PHAP25-00044

Date: December 4, 2025
Application Type: Certificate of Appropriateness
Property Owner: Luis Tarango
Representative: Lorena Armenta
Legal Description: 30 Manhattan Heights W 66 Ft Of 6, City of El Paso, El Paso County, Texas
Historic District: Manhattan Heights
Location: 2801 Silver Avenue
Representative District: #2
Existing Zoning: R-3/H (Residential/Historic)
Year Built: 1950
Historic Status: Contributing
Request: Certificate of Appropriateness for the construction of a rear addition and the installation of a deck
Application Filed: 11/20/2025
45 Day Expiration: 1/4/2026

Certificate of Appropriateness for the construction of a rear addition and the installation of a deck

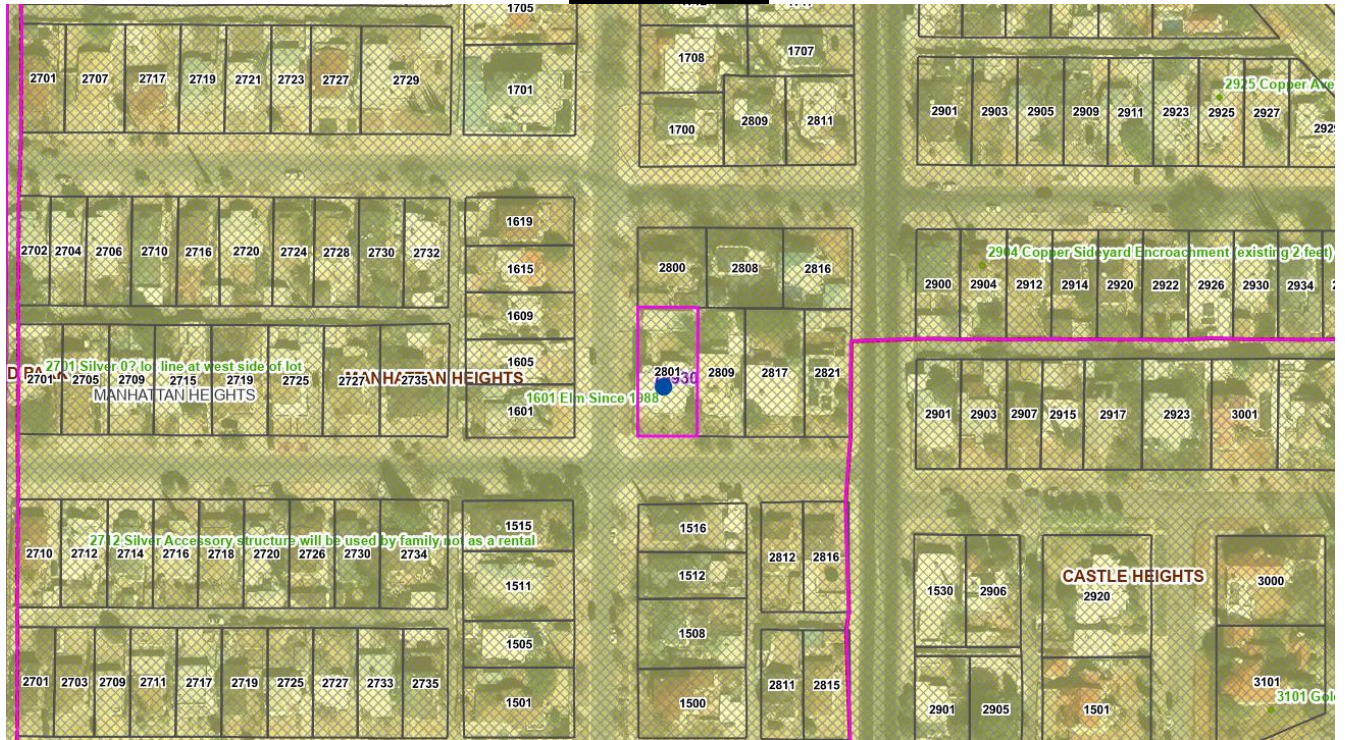
The modifications are that the addition be redesigned to be subtly different from the existing architecture; that the new windows match the existing or historic windows in terms of dimensions, operation, configuration, and finish; and that window drawings be submitted for all proposed windows to be replaced.
